City of Rockville

MEMORANDUM

SUBJECT: Use Permit Amendment application USA2003-0670B, Rockville Town Square Public Streets, Public Park and Adjacent Landscape and Hardscape Use Permit; Federal Realty Investment Trust, Applicant.

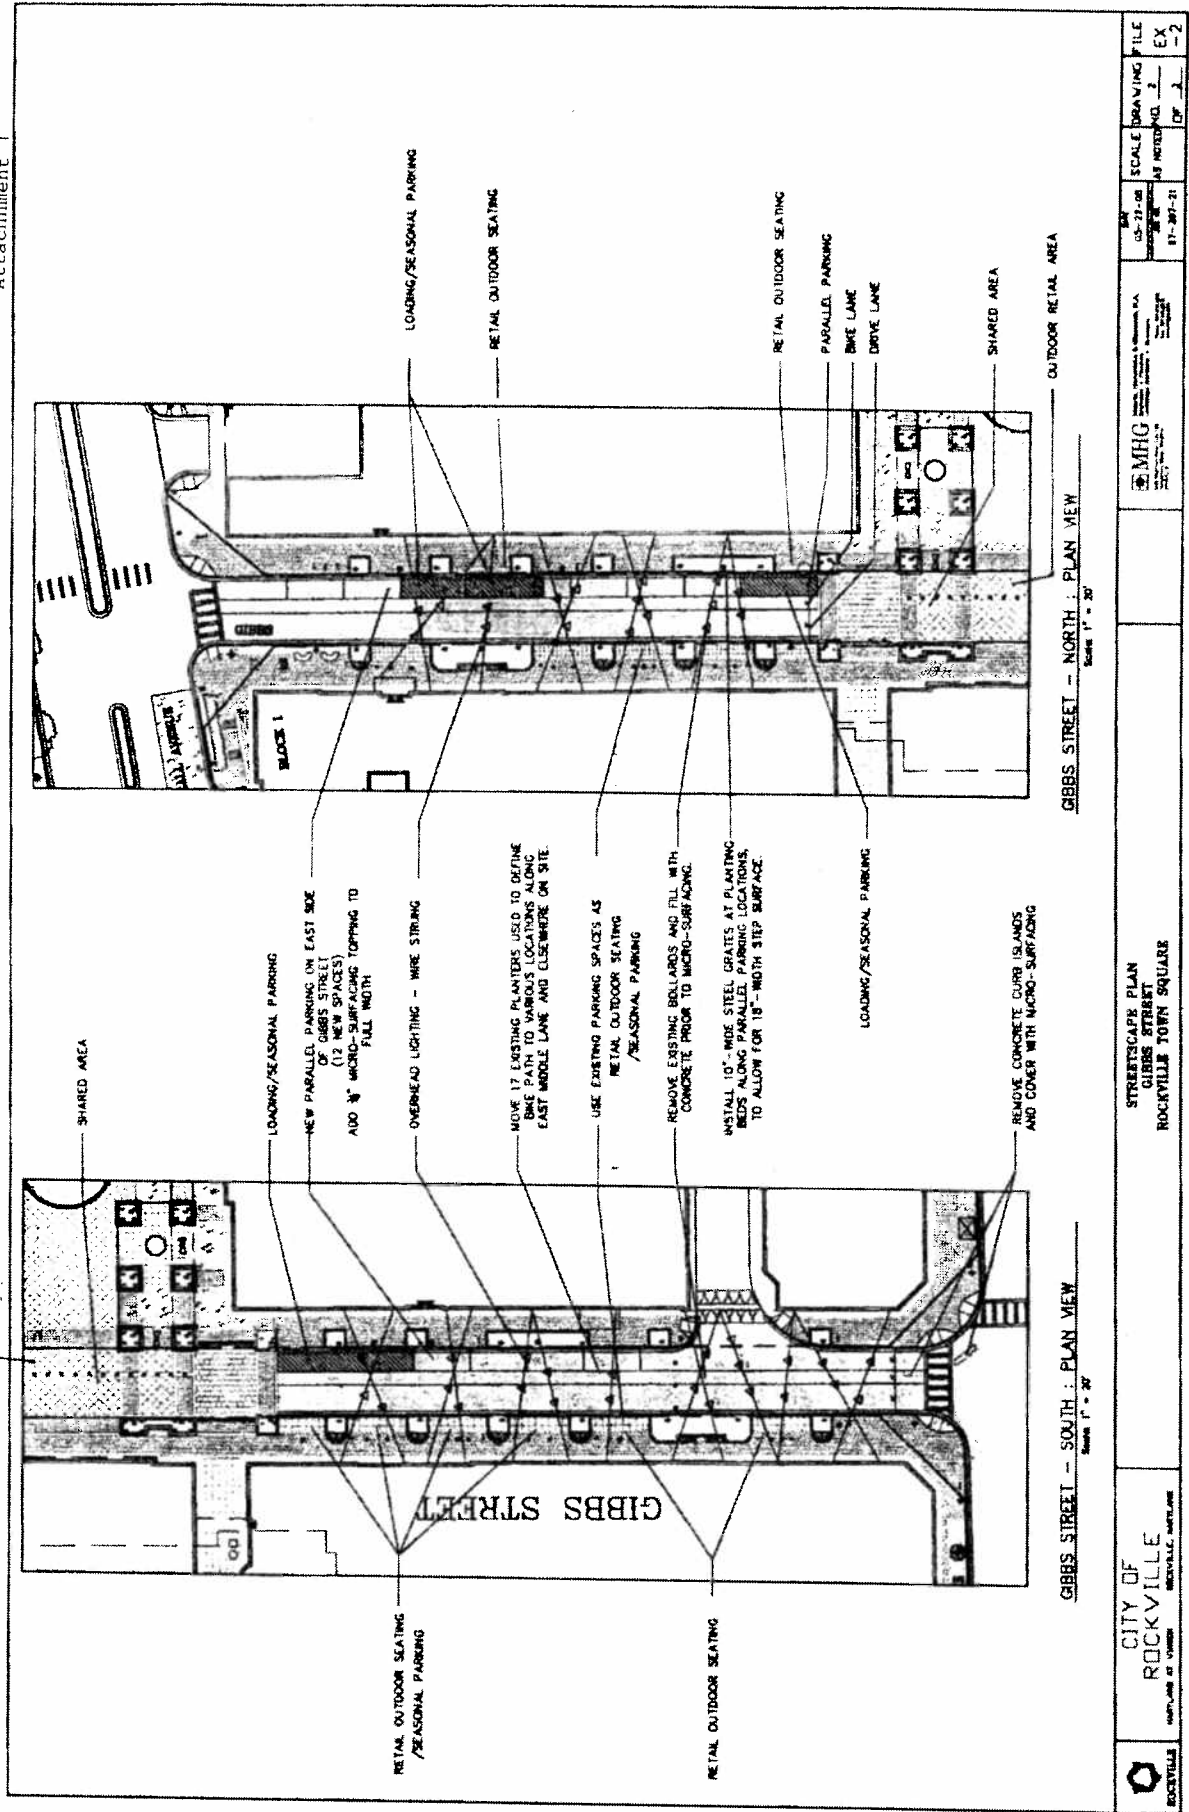
The proposed amendment would modify the design of Gibbs Street in order to allow installation of 12 on-street parking spaces on the east side, and removal of the bollards and planters that currently separate the bike lane from the travel lane. The street would be resurfaced in its entirety with a thin surfacing material, allowing for an 11-foot wide travel lane; a 5-foot bike lane, and curb-side parking. The bike lane divider "humps" at the entrance to Gibbs Street from East Middle Lane will also be removed. In addition, the application also proposes to hang decorative lighting across the width of the street. Also, where the new parking spaces are next to the existing planter areas along the curb, ten-inch wide steel grates will be installed at the back of the curb so that people exiting on the passenger side of the car will have a safe place to step.

The current "convertible" parking spaces on the west side of Gibbs Street will become seasonal use spaces. They can be used as outdoor seating areas during the warmer months, and revert to parking spaces during the colder months. This is essentially how they function today.

Several of the areas along the east side curb will be designated for use as loading areas and/or seasonal parking. That portion of the plaza area between the curb line and the original bike lane area will retain the bollards and become available for added outdoor retail area for transient vendor kiosks.

The decorative overhead lighting will be hung from span wires attached to the building faces along the street. They will be installed with a minimum overhead clearance of 15 feet to accommodate trucks and emergency vehicles.

Finally, there has been a problem with storm water drainage at the entrance to the parking garage for Block 3B on the east side of Gibbs Street. The water flows down into the garage instead of to the storm drains along the street. Public Works recommends that this be corrected as part of the alterations to Gibbs Street.

Staff has reviewed the proposed modifications and supports the proposed changes. The staff therefore recommends that this use permit amendment application be approved with the following conditions:

1. No support wires for the overhead lighting will pass through the canopies of the existing street trees.
2. The utilization of the sidewalk areas and convertible parking spaces on west side of Gibbs Street for outdoor seating cannot exceed the overall limit of 70% of the total outdoor dining area as set forth in the original conditions of approval dated March 9, 2004.

3. The applicant must execute a license agreement acceptable to the City Attorney for use of the area over the public street for decorative lighting installation.

4. Bike facilities will comply with the Bicycle Master Plan. This may include either striping or other directional indicators at the direction of the Director of Public Works.

5. Correct the stormwater drainage problem at the entry to the Block 3B garage so that water does not flow into the garage.
6. All other applicable conditions of the original approval to remain in effect.
